IEEE 802.16maint-04/10

**Corrigendum to IEEE Standard for Local and  
Metropolitan Area Networks - Part 16: Air Interface  
for Fixed Broadband Wireless Access Systems**

**Abstract:** This corrigendum contains substantive corrections to IEEE Standard 802.16-2004. It corrects errors, inconsistencies, and ambiguities in that standard. It does not contain new material.

Figure 36—ARQ block reception

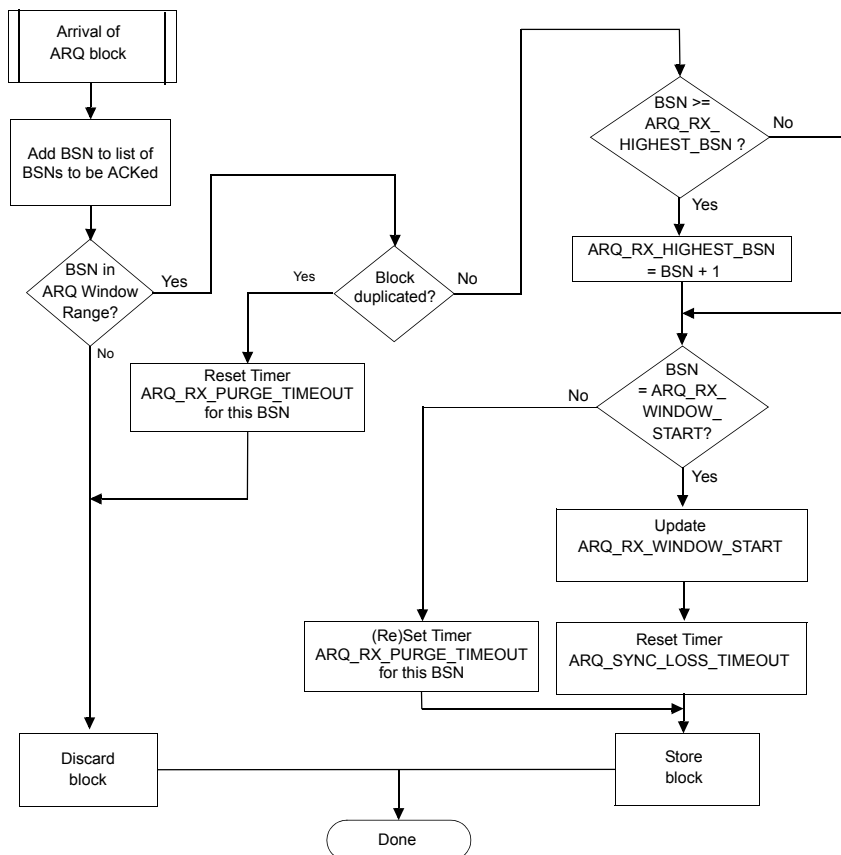
Replace Figure 36 with the following figure:

**Table 107—CDMA initial Ranging and automatic adjustments procedure**

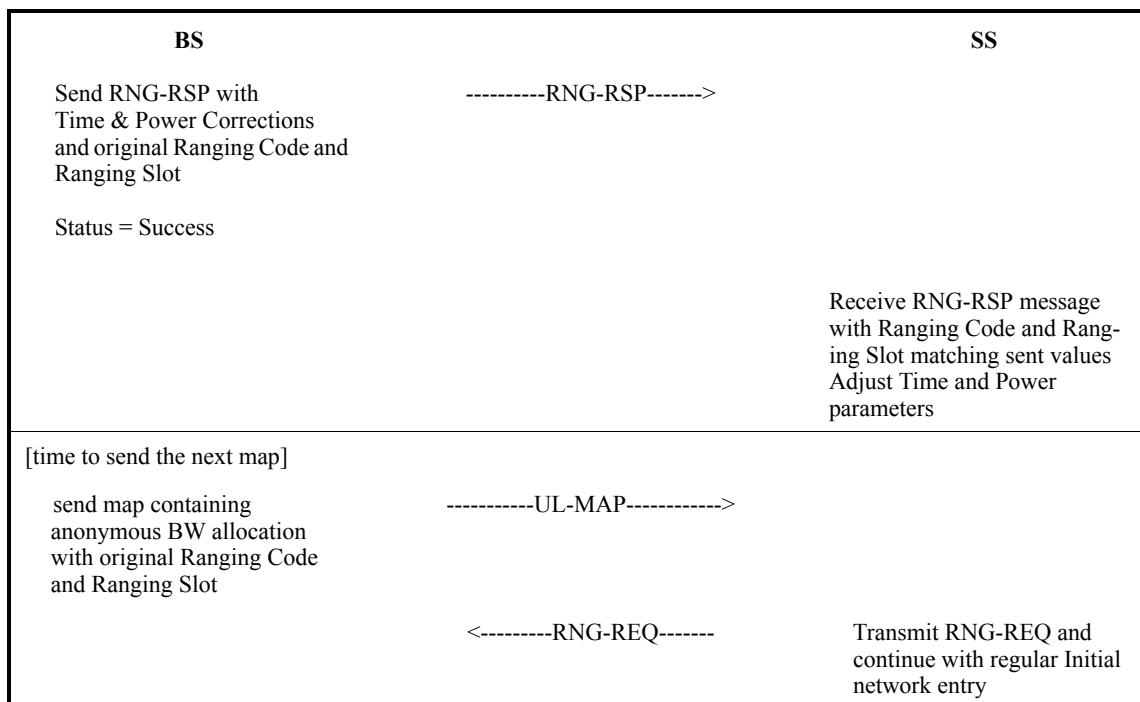
*Change Table 121 as indicated:*

**Figure 95—Theory of Operation Object Model**

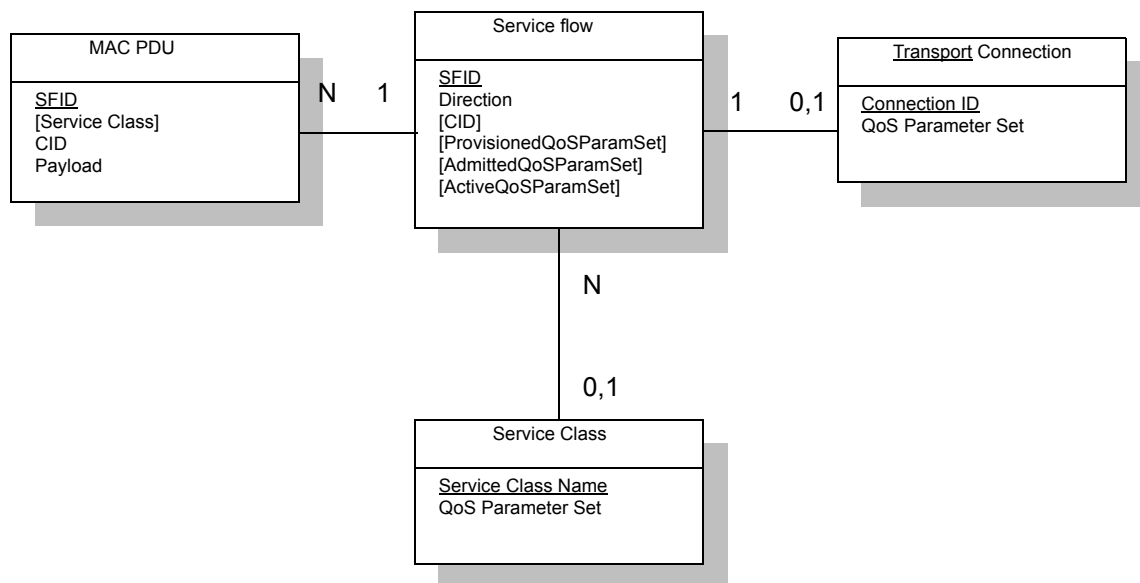
*Change Figure 95 by addition of “Transport” before “Connection”:*

**Figure 96—Time plan - one TDD time frame (with only mandatory zone)**

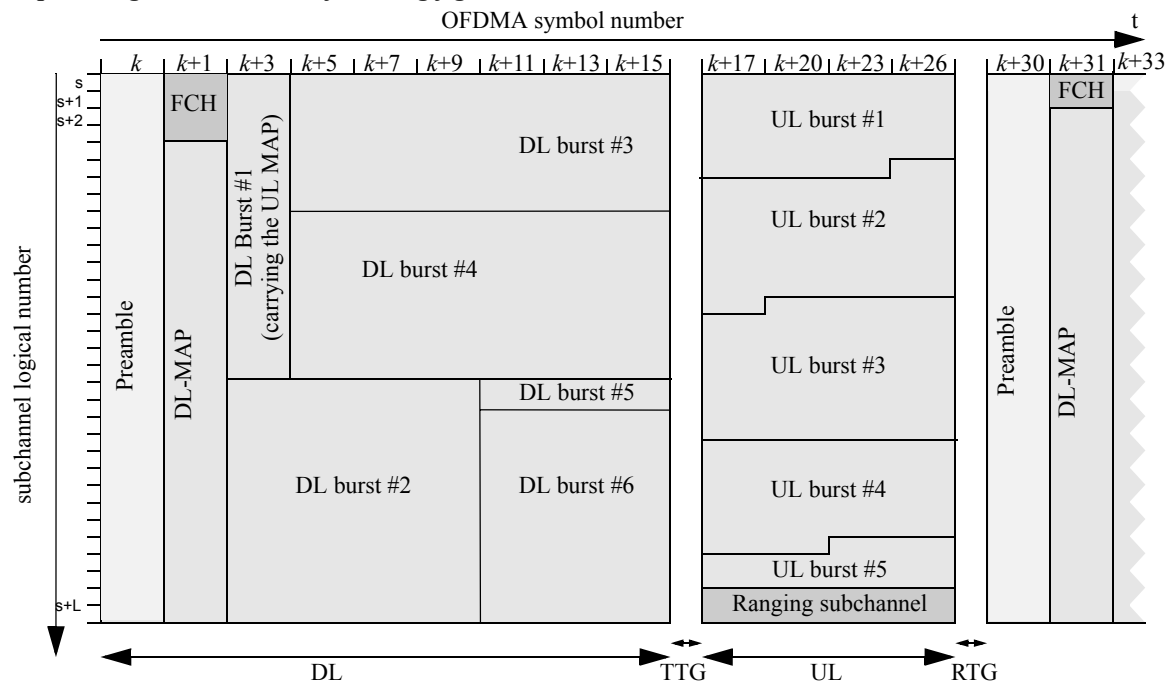
**Replace Figure 218 with the following figure:**

**Figure 223—Example of allocation for IE AAS-DLFP**

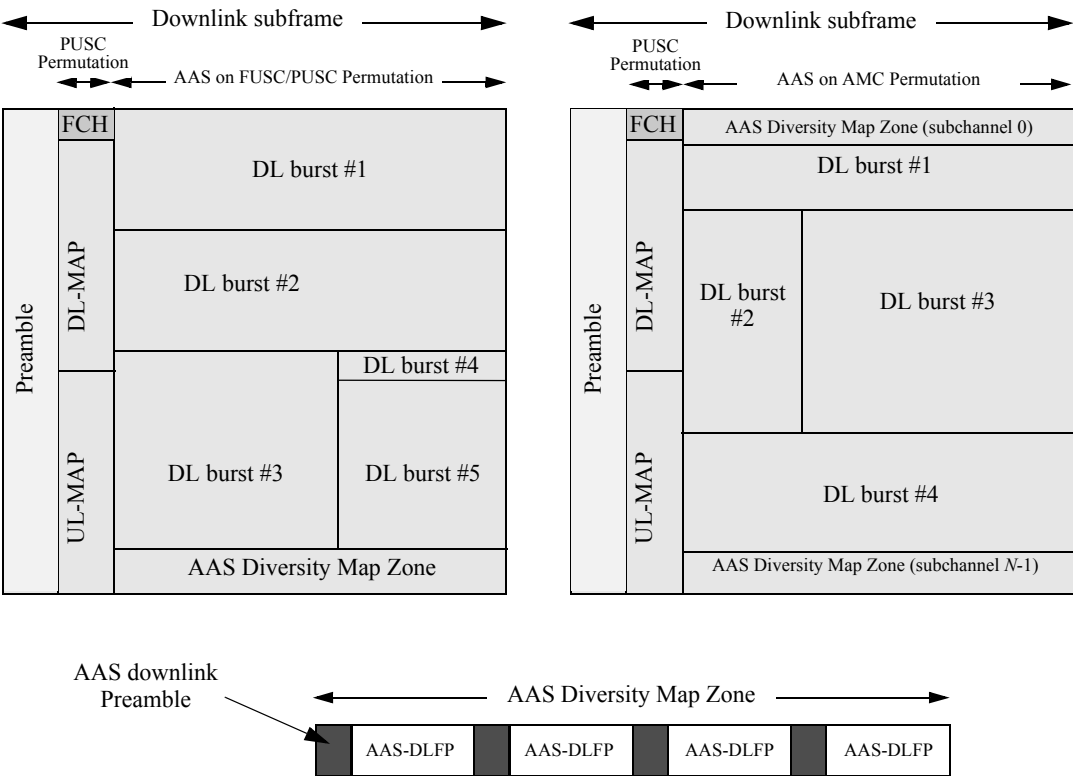
*Replace Figure 224 with the following figure:*

**Figure 239—Initial-ranging transmission for OFDMA**

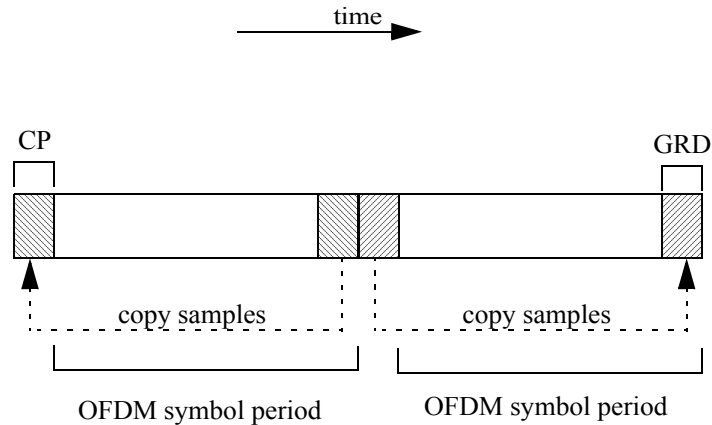
*Replace Figure 239 with the following figure:*

*Insert the following sentence below Figure 239:*

The transmitted signal is according to 8.4.2.5, equation (100), except that  $0 \leq t \leq 2T_s$ .

**Figure 240—Initial-ranging transmission for OFDMA, using two consecutive initial ranging codes**

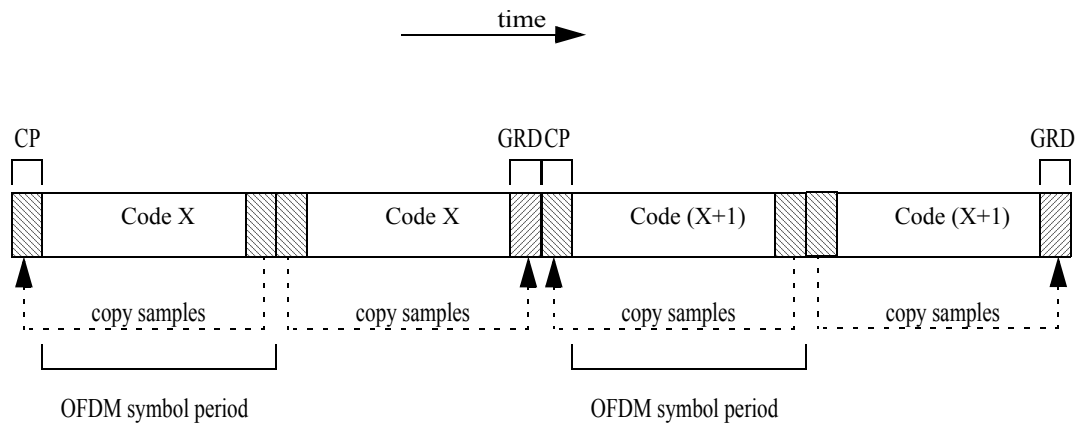
Replace Figure 240 with the following figure:
